TITLE: FUSELAGE - MAIN STRUCTURE - INTRODUCE COLD WORKING AT STOP FITTING FR66 / FR68

MODIFICATION No.: 156085G0974

This page transmits Revision No.01 of Service Bulletin No.A320-53-1290

Revision No. 01 issued to extend the effectivity of this Service Bulletin and to add West Coast Industries (WCI) as alternative supplier for cold working tools.

Figure A-SBAAA - Sheet 01
Modification of the holes in frame web and stop fittings

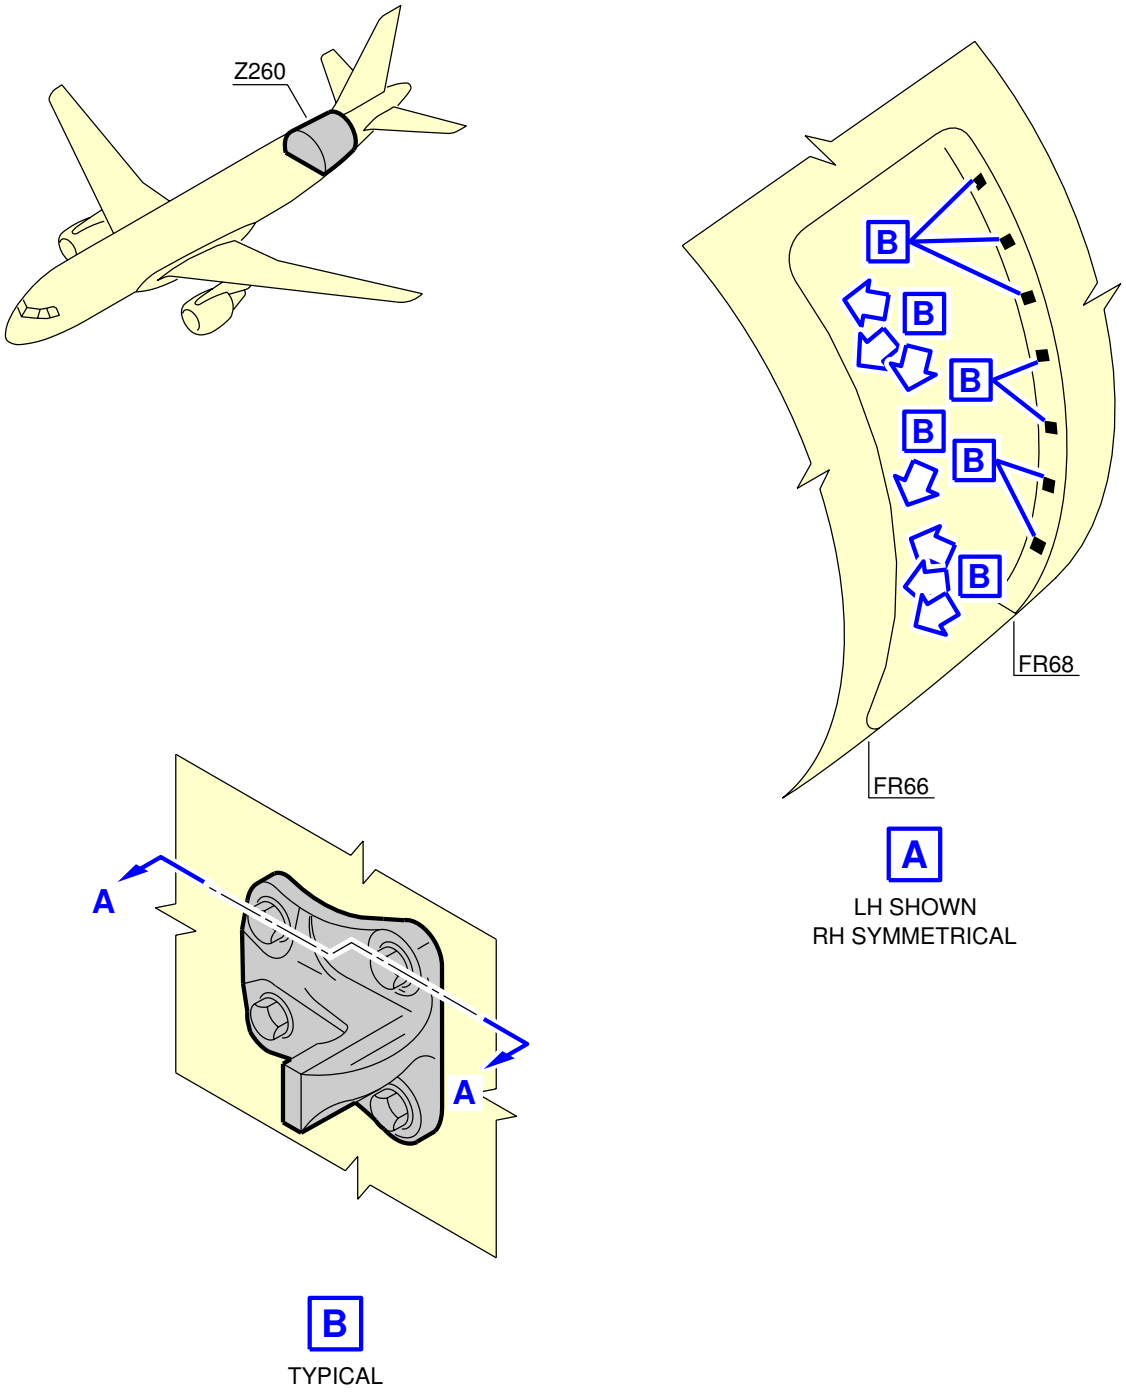
(1) Remove the Stop Fittings on LH Side

(5) Do the Cold Working Process in Frame Web Holes on LH Side

(7) Oversize the Stop Fitting Holes on LH Side

Figure A-SBAAA - Sheet 02
Modification of the holes in frame web and stop fittings

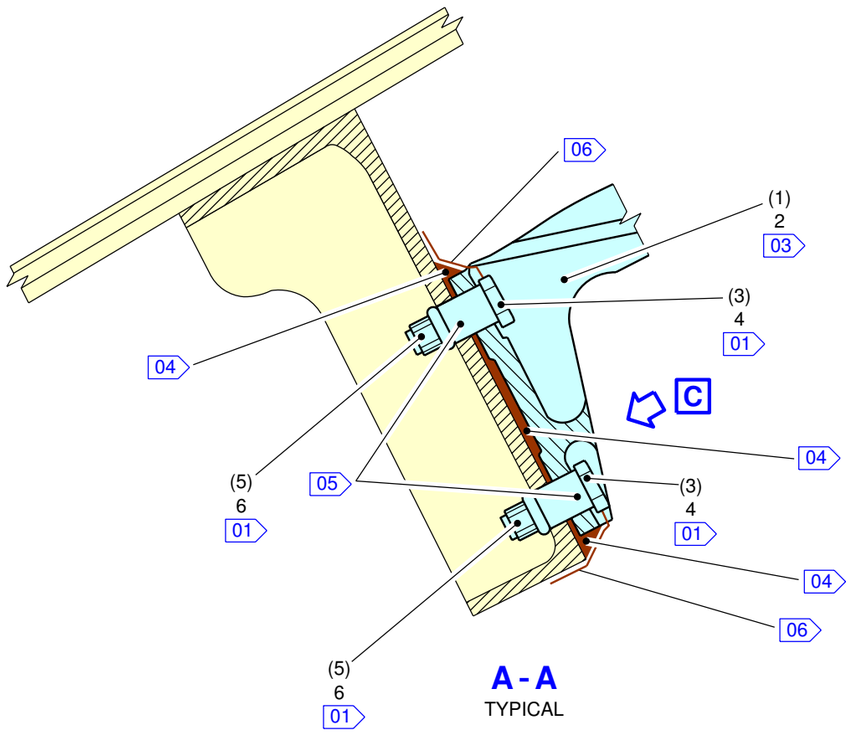
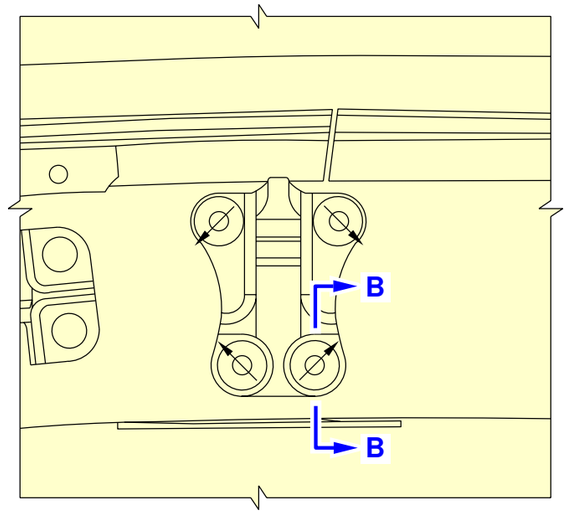
- Effectivity extended
- Paragraph MATERIAL INFORMATION updated
  - . Procurement address updated
  - . Availability of Kit 531290C01R00 updated
  - . Standard tool TOOLC01 updated
  - . WCI added as an alternative supplier for cold working tools
- Figure A-SBAAA modified
  - . Diameter of the four stop fitting holes modified
- Minor changes applied.

Subtask 531290-941-601-001	SUBTASK SOLUTION UPDATED NOTE UPDATED	R
Subtask 531290-020-601-001	SUBTASK SOLUTION UPDATED NOTE UPDATED CONFIGURATION UPDATED	R
Subtask 531290-020-602-001	SUBTASK SOLUTION UPDATED NOTE UPDATED CONFIGURATION UPDATED	R
Subtask 531290-831-601-001	SUBTASK SOLUTION UPDATED TOOL UPDATED REFERENCED DOCUMENTATION UPDATED NOTE UPDATED QUANTITY UPDATED CONFIGURATION UPDATED FIGURE REFERENCE UPDATED MATERIAL LIST UPDATED	R
Subtask 531290-831-602-001	SUBTASK SOLUTION UPDATED TOOL UPDATED REFERENCED DOCUMENTATION UPDATED NOTE UPDATED QUANTITY UPDATED CONFIGURATION UPDATED FIGURE REFERENCE UPDATED MATERIAL LIST UPDATED	R
Subtask 531290-831-603-001	SUBTASK SOLUTION UPDATED	R
Subtask 531290-831-604-001	SUBTASK SOLUTION UPDATED	R
Subtask 531290-942-601-001	SUBTASK SOLUTION UPDATED	R
Fig. A-SBAAA		
Fig. A-SBAAA Sheet 02	SHEET UPDATED	R

(c) After removal of each fasteners, check on the aircraft the existing hole diameters (6.327mm (0.249in.) to 6.347mm (0.250in.)) and compare with the values of the tables given in the Fig. A-SBAAA Sheet 02 of the Service Bulletin in order to identify deviations.

(c) After removal of each fasteners, check on the aircraft the existing hole diameters (6.327mm (0.249in.) to 6.347mm (0.250in.)) and compare with the values of the tables given in the Fig. A-SBAAA Sheet 02 of the Service Bulletin in order to identify deviations.
